Pflugerville
Planning and Zoning
Commission
AGENDA REPORT

Planning and Zoning: 7/2/2018 **Staff Contact:** Abigail Rose, Planner II
Agenda Item: 2018-6848 **E-mail:** abbeyr@pflugervilletx.gov
Case No. ARB1805-01 **Phone:** 512-990-6306

SUBJECT: Discuss and consider an application for an Architectural Waiver to waive the requirement of the covered rear patio for the alley-loaded products with attached garages in the Carmel development. (ARB1805-01)

Figure 1: SF-MU Alley-Loaded, Attached Garage Example 1

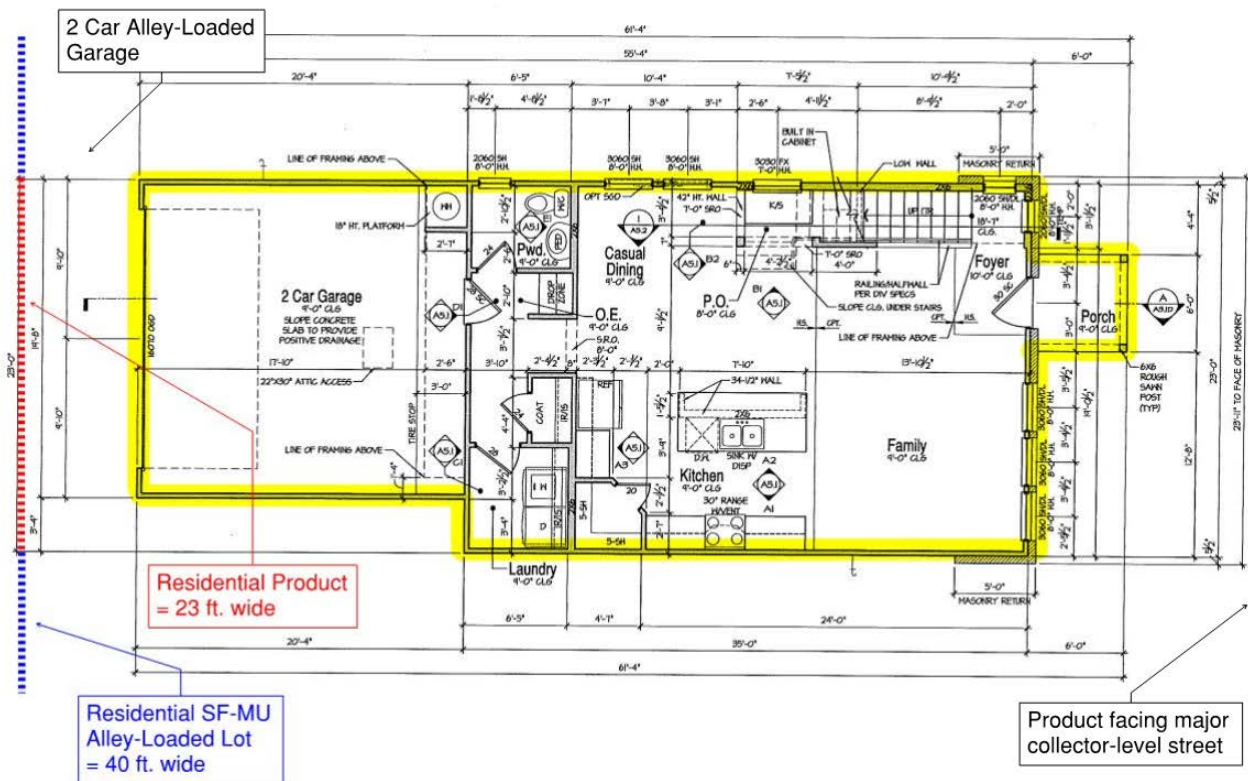
The Applicant is requesting a waiver for the 100 sq. ft. minimum covered rear patio requirement associated with the architectural standards of the Unified Development Code (UDC) and First Amendment of the Carmel Development Agreement. The Applicant has stated the required covered rear patio is challenging to build at the rear due to the attached garage in combination with both the residential dwelling’s lot width and mandatory 2 car alley-loaded garages. Please refer to the examples, *fig. 1 & 2*, provided below.

The proposed waiver identifies the challenge to build a rear covered patio on an alley-loaded product with an attached garage. The 40 ft. wide alley-loaded, attached garage products leave little to no room or access for the addition of a 100 sq. ft. minimum covered rear patio. The requirement of the 100 sq. ft. minimum covered rear patio could result in a covered patio extending over a driveway, which is not the intent of the code requirement. Staff recommends the approval of the proposed architectural waiver to waive the requirement of the 100 sq. ft. minimum covered rear patio for all alley-loaded products with an attached garage in the Carmel development. All other alley-loaded products which do not include an attached garage shall meet the architectural standards of Subchapter 9 of the Unified Development Code (UDC) and the First Amendment of the Carmel Development Agreement.

minimum covered rear patio requirement; therefore, staff recommends that the 100 sq. ft. minimum covered rear patio requirement be waived for all alley-loaded products with an attached garage within the Carmel development. All other alley-loaded products which do not include an attached garage shall meet the architectural standards of Subchapter 9 of the Unified Development Code (UDC) and the First Amendment of the Carmel Development Agreement. Please refer to the Location Map exhibit attached to this document, which shows the location of the established and potential alley-loaded products within the Carmel development. The 40 ft. wide established and potential alley-loaded products, which would be subject to this architectural waiver, are located along the following streets within the Carmel development: Pleasanton Parkway (60 ft. Right-Of-Way) and Wolf Pack Drive (60 ft. Right-Of-Way).

Figure 3: Location of Applicant's Alley-Loaded, Attached Garage Products

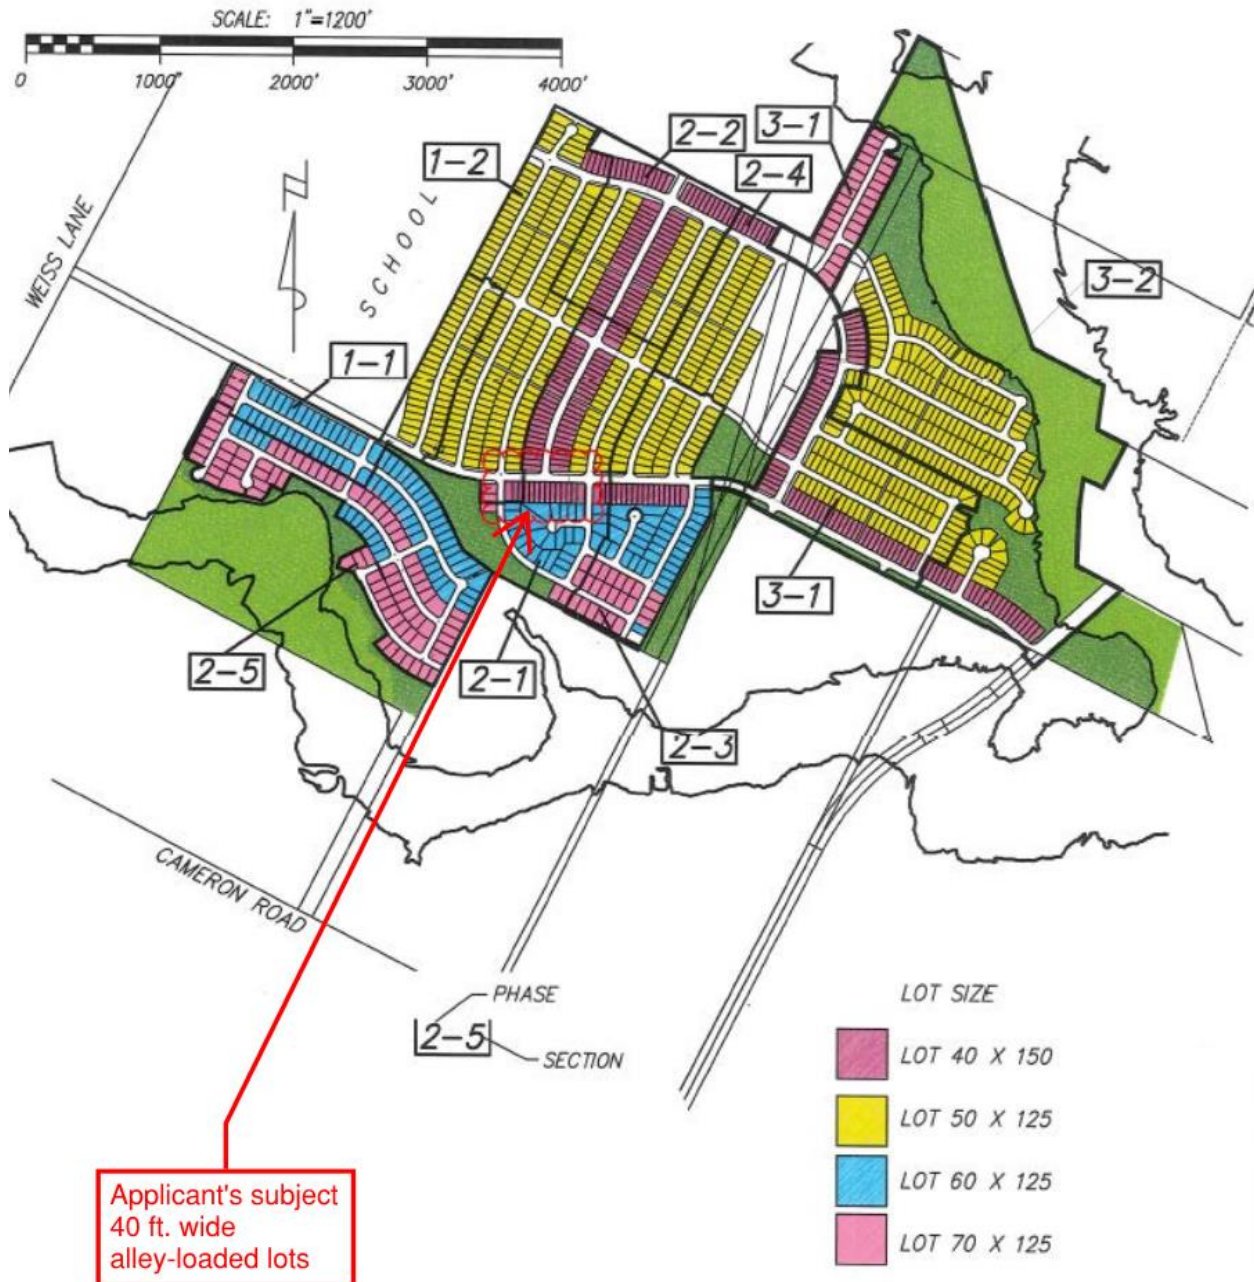
The Applicant will build on a total of fourteen (14) 40 ft. wide Single Family Mixed Use Residential (SF-MU) District alley-loaded lots within the Carmel development. Three (3) of the lots are located in Phase 1, Section 2, Block F (Lots 1, 2, and 3), while the remaining fourteen (14) lots are located in Phase 2, Section 1 of the development, which has not been platted at this time. All of the subject lots front Pleasanton Parkway. Please refer to the image, *fig. 3*, provided below.
